PLANNING COMMISSION AGENDA
Monday, March 28, 2022 at 6:00 p.m.
Caledonia Village Hall – 5043 Chester Lane

PLAN COMMISSION REPORT

Description: Review a request for a conditional use and a proposed building, site, and operation plan to construct a ±28,638 square-foot speculative commercial building with 14 acres of outdoor storage for the parcel located north of 7301 USH 41.

**SITE GRADING &
STORM SEWER PLAN** **C2.0**

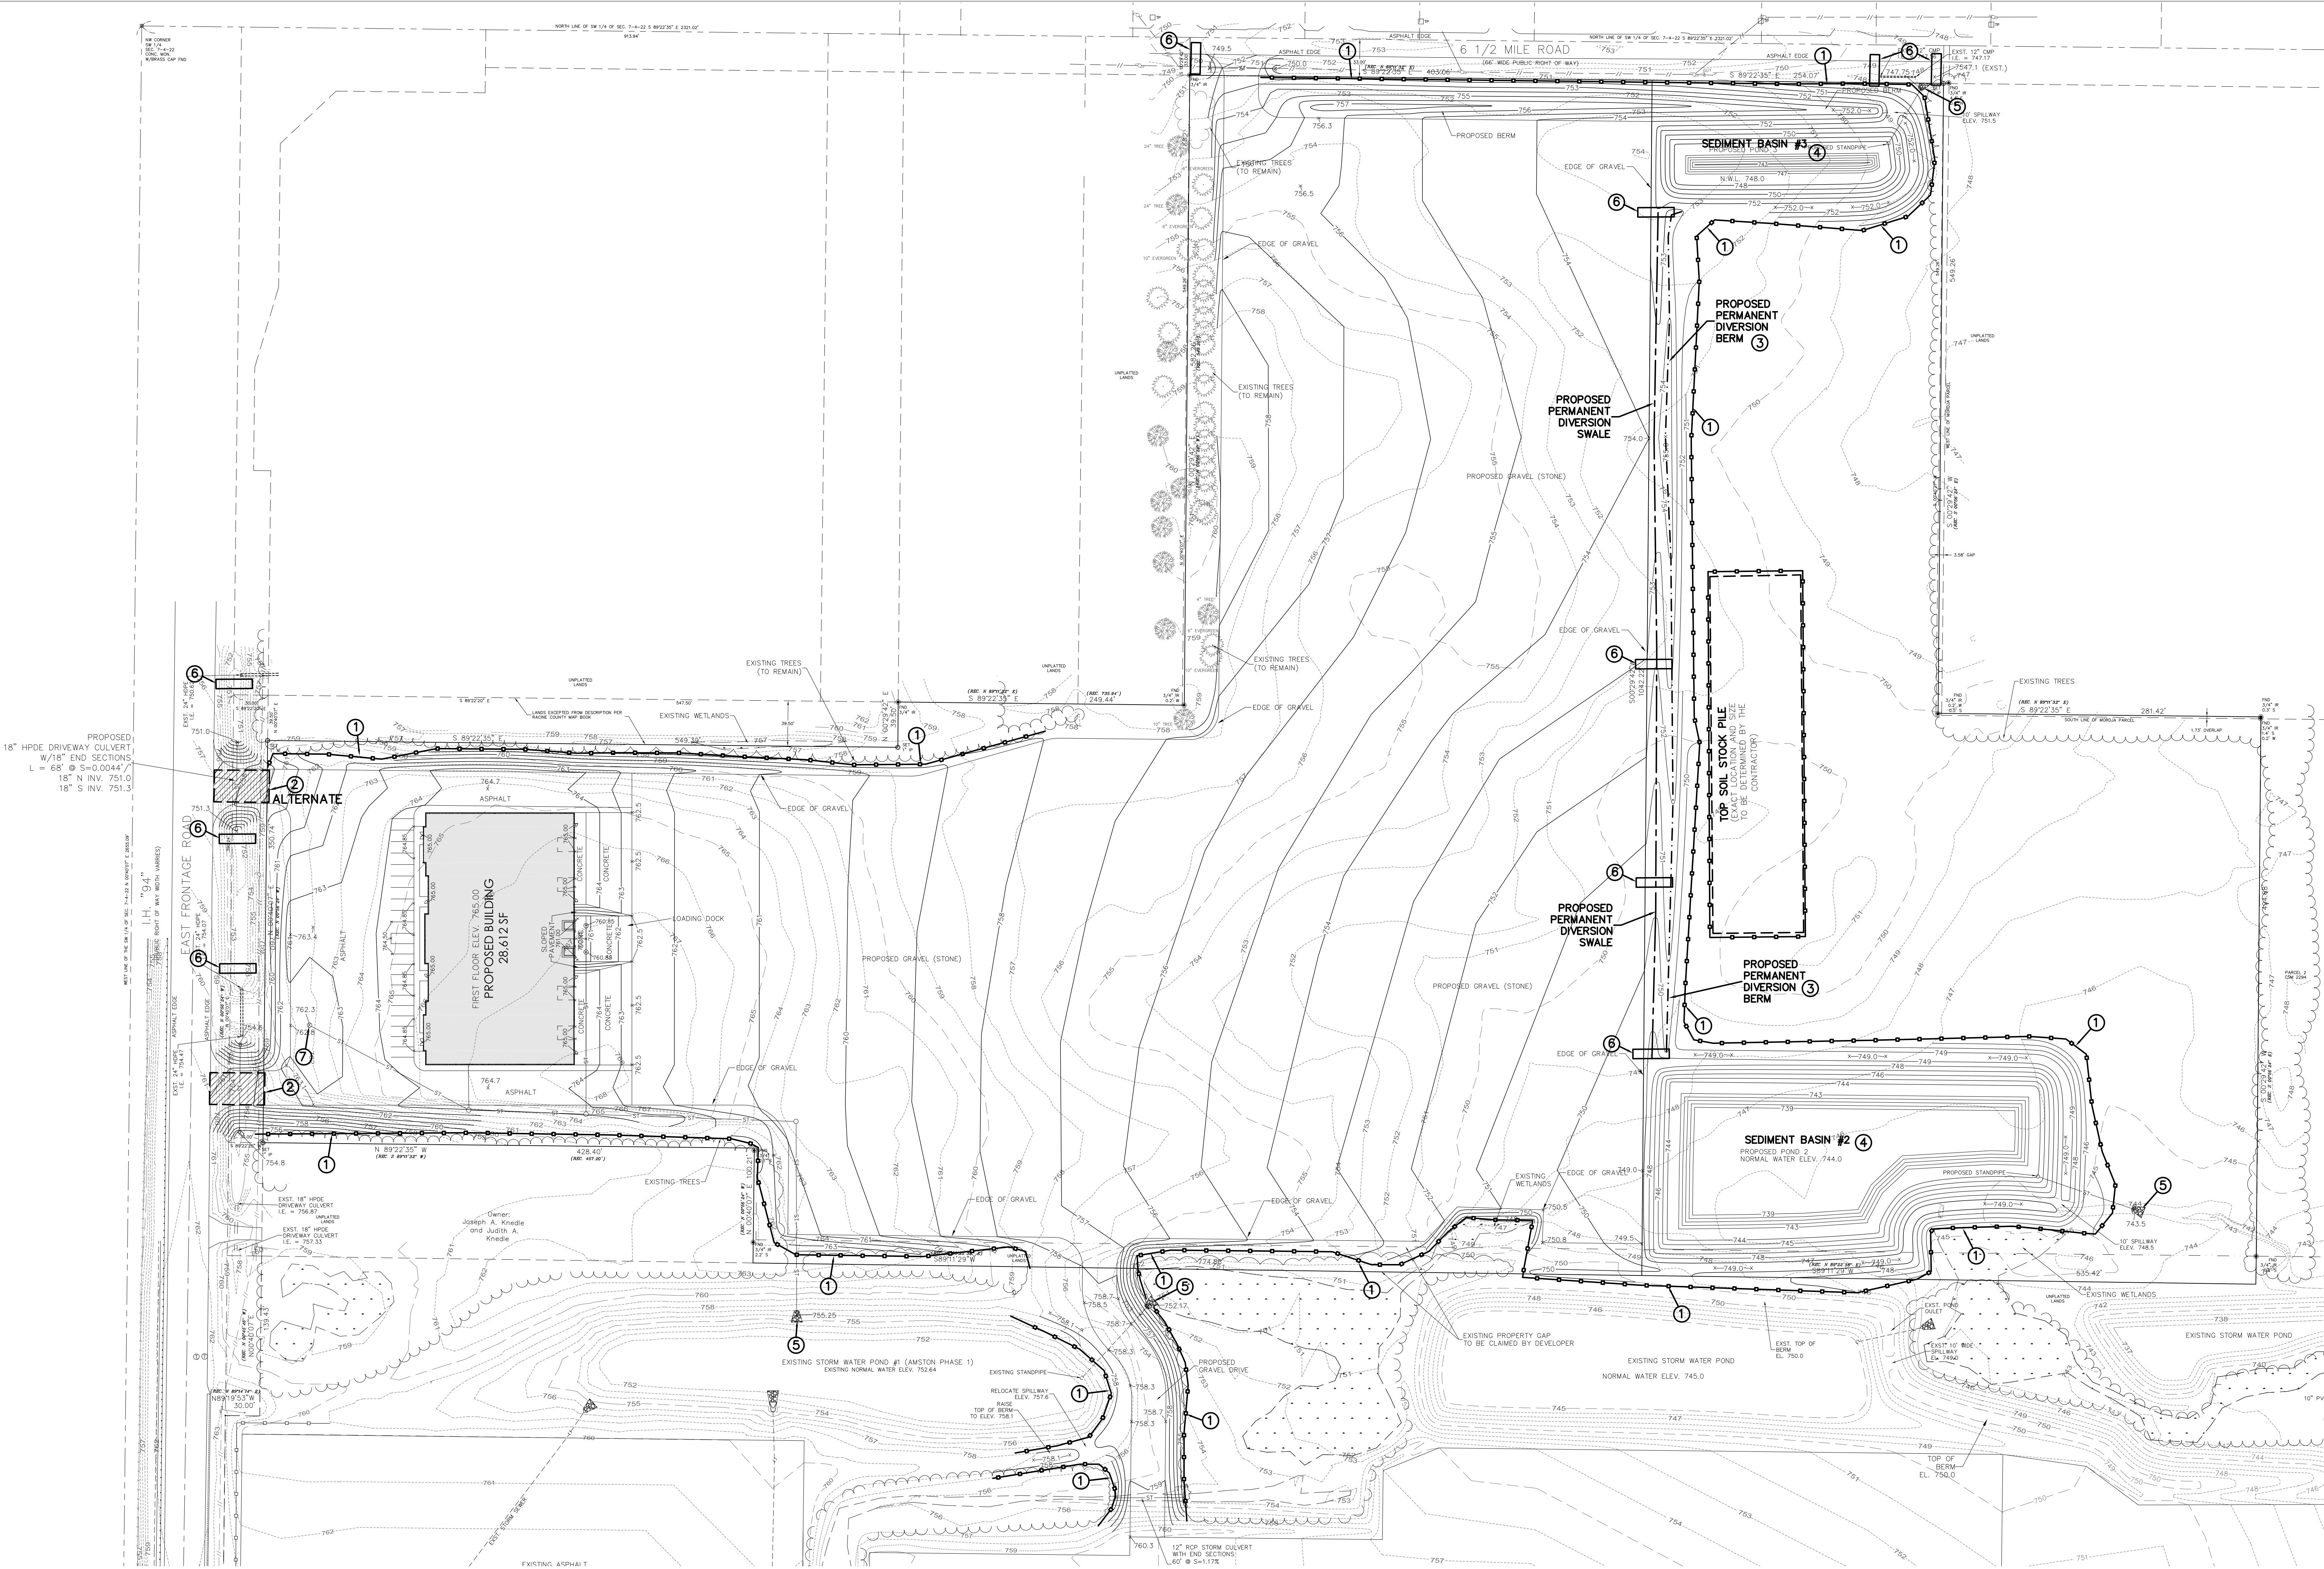
- The proposed stormwater plan shows discharging of stormwater to a storm water pond on the adjacent parcel. This is not permitted. Staff recommends creating an outlot containing the storm water pond that services both parcels. This would require a CSM and modification to the site plan.
